**From:** DC Department of Buildings <dob@dc.gov>  
**Sent:** Monday, September 8, 2025 11:26 AM  
**To:** [REDACTED]  
**Cc:** [REDACTED]  
**Subject:** Re: FW: Request for Confirmation | Bridge District Parcel 5 | Elevator Vestibule  
**Attachments:** ZC\_25-07\_Elevator\_Vestibule\_Info.pdf

I am writing to follow up on our prior discussions regarding the proposed mixed-use development at 633 Howard Road, SE (Square 5861, Lot 1070) (the “Property”), otherwise known as Parcel 5 of the Bridge District. The Property contains approximately 33,326 square feet of land area and is located in the Northern Howard Road (“NHR”) zone district. The Property is currently unimproved. My client, BD Parcel 5 LLC (an affiliate of Redbrick LMD), intends to build a mixed-use building (the “Parcel 5 Building”) containing approximately 299 residential dwelling units, approximately 8,476 square feet of ground floor retail, and approximately 160 vehicle parking spaces (the “Project”). The Project will have an overall floor area ratio of approximately 7.21, and will be constructed to a maximum height of 130 feet, plus a 20-foot penthouse that contains mechanical and habitable space. Pursuant to K-1005.1

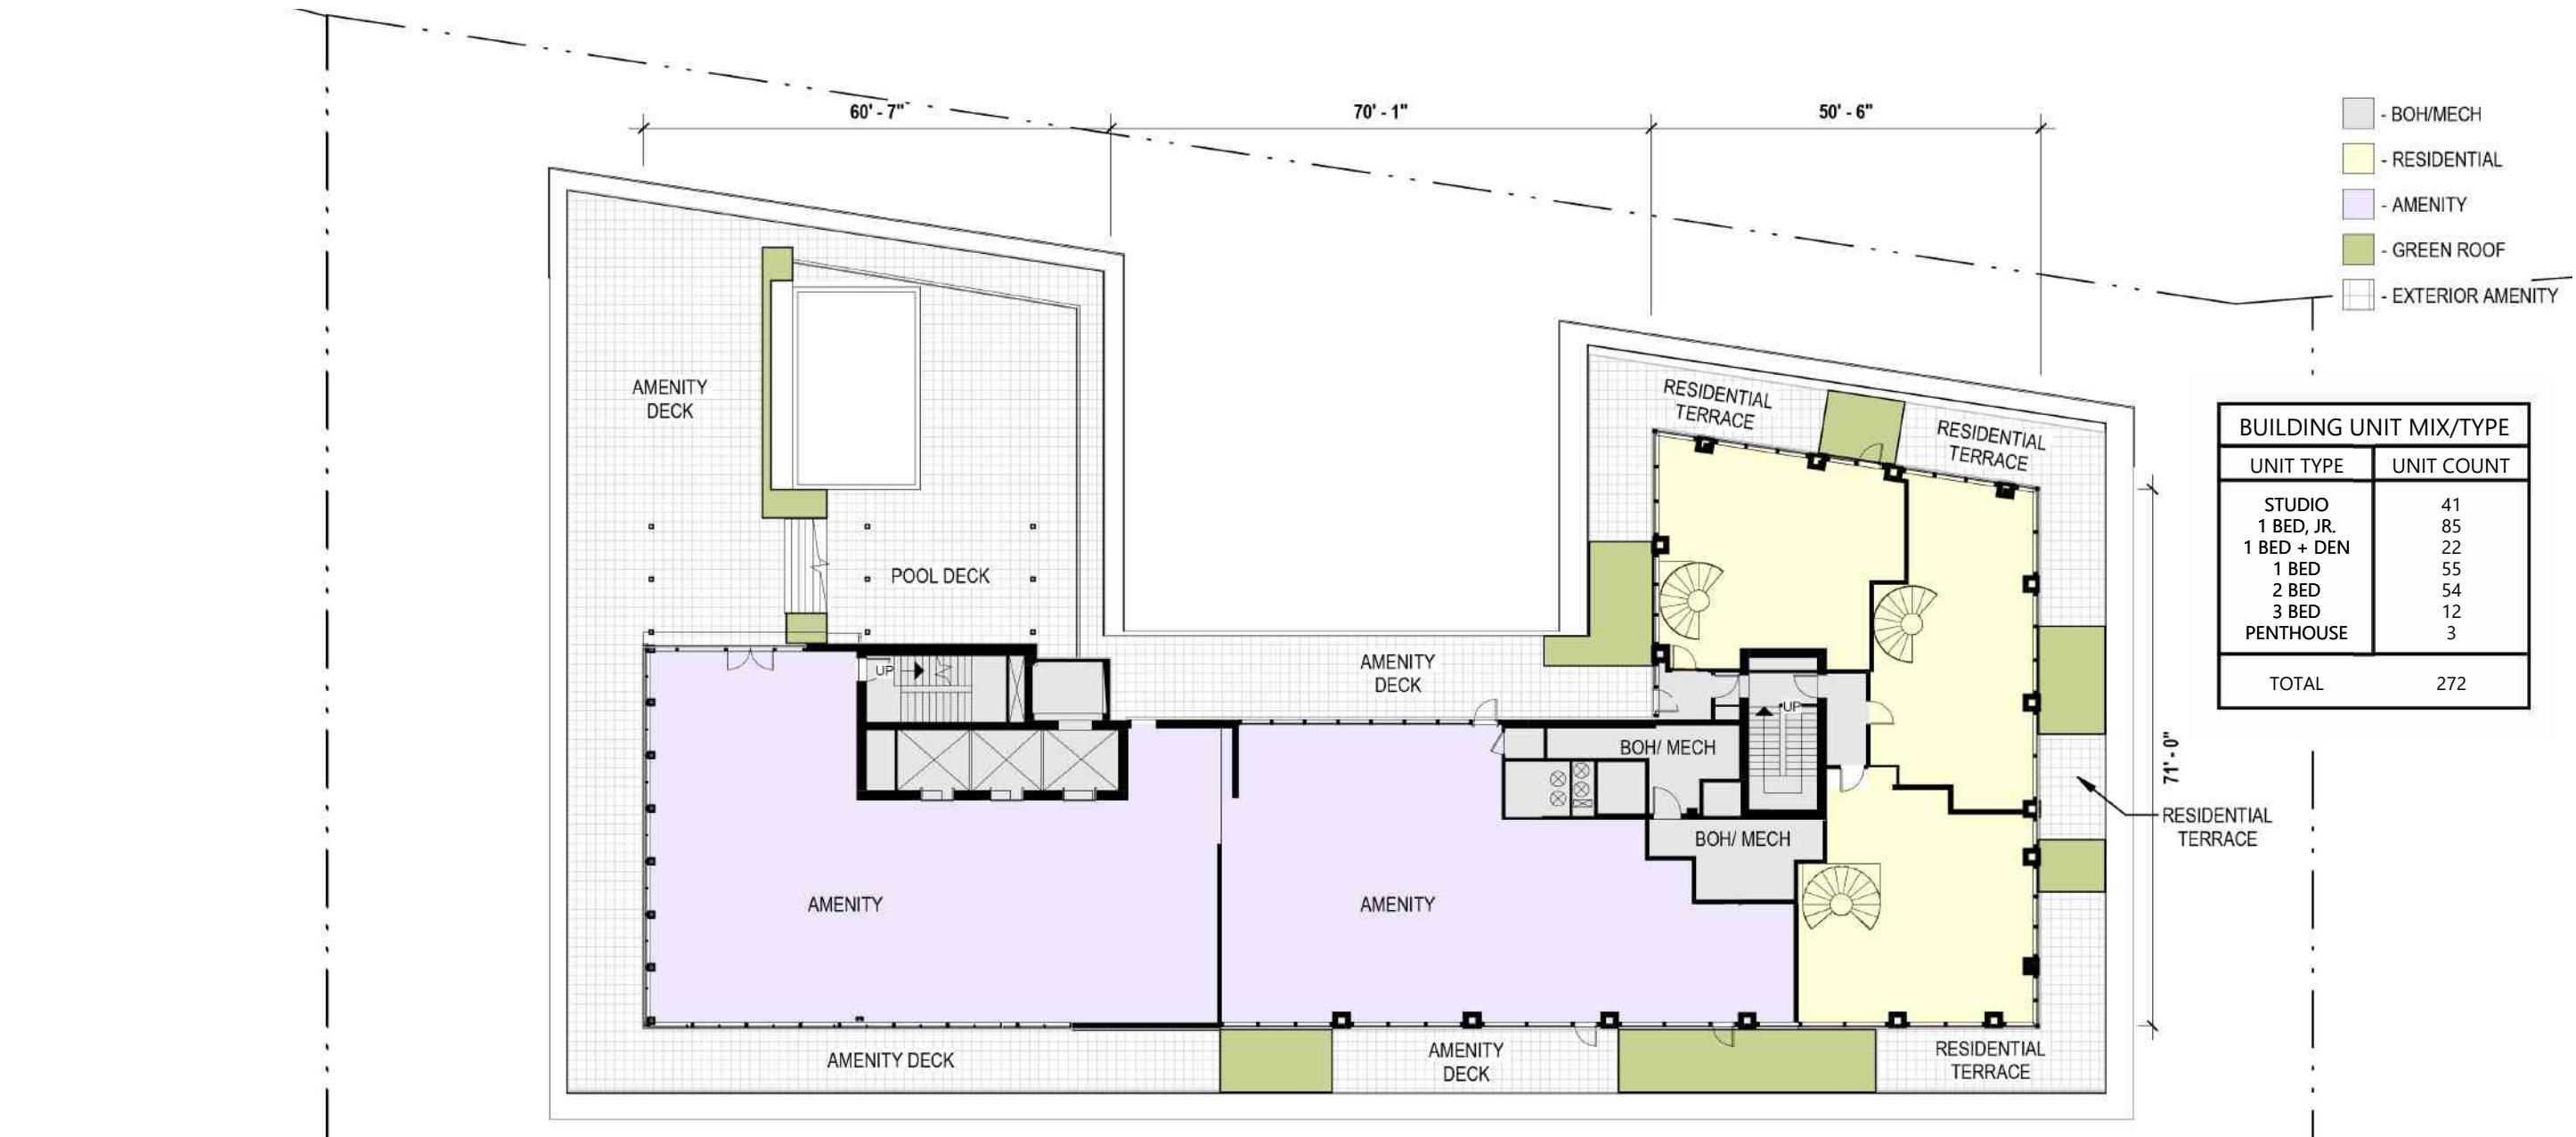
As we discussed on Friday, September 5, 2025, The proposed vestibule is adjacent to the southernmost elevator of the proposed building, which is the only elevator in the project that can access the pool deck due to a stair tower and vent shaft that run the full height of the building and emerge on the roof directly behind the other two elevators. The minimum size of the elevator vestibule is dictated by ICC A117.1, Section 304.3 of the International Construction Code. That provision requires a 5'-0" minimum turning space, which sets the minimum inside clear dimension from the elevator door at 5'-0". As shown in the attached roof plan and isometric drawings of the vestibule, because of the location of the elevator, the elevator door is slightly offset from the door to the pool deck. Moving the elevator door is not feasible based on elevator hoistway requirements. This makes the minimum area needed for the vestibule 45 square feet to meet the 5'-0" turning radius and accommodate the door offset. The proposed vestibule is 45 square feet. The height of the vestibule has also been minimized. Per ICC A117.1, objects cannot be located less than 6'-8" (80") overhead. This, however, is superseded by DC Building Code Section 1003.2, which requires 7'-6" minimum clearance. The proposed vestibule has an interior clear height of 7'-6". When we met, we asked whether accessibility / ADA requirements require enclosed space. You subsequently share that while the requirements do not address whether the space needs to be enclosed, in this instance, providing an exterior opening for an otherwise interior elevator shaft is problematic for two reasons. First, the elevator door that opens into the proposed vestibule would need additional weather protection to prevent rain/snow/moisture from entering the elevator shaft. Secondly, the elevator door is less effective than a solid wall or vestibule at managing thermal bridging. Thus, an exterior elevator door that is exposed to the elements may create an unintended thermal bridge into the elevator shaft, which may in turn cause condensation issues in spaces adjacent to the shaft. Both issues would create weaknesses in the building’s moisture management strategy, which is of particular concern in a mass timber wood building such as this.

Based on the above, I am writing to confirm that the proposed accessible elevator vestibule can be considered a part of the proposed elevator to which it is connected for this project. The proposed vestibule would qualify for the setback exemption under C-1504.4, and thus would not be impacted by the restriction on setback relief imposed under C-1506.2.
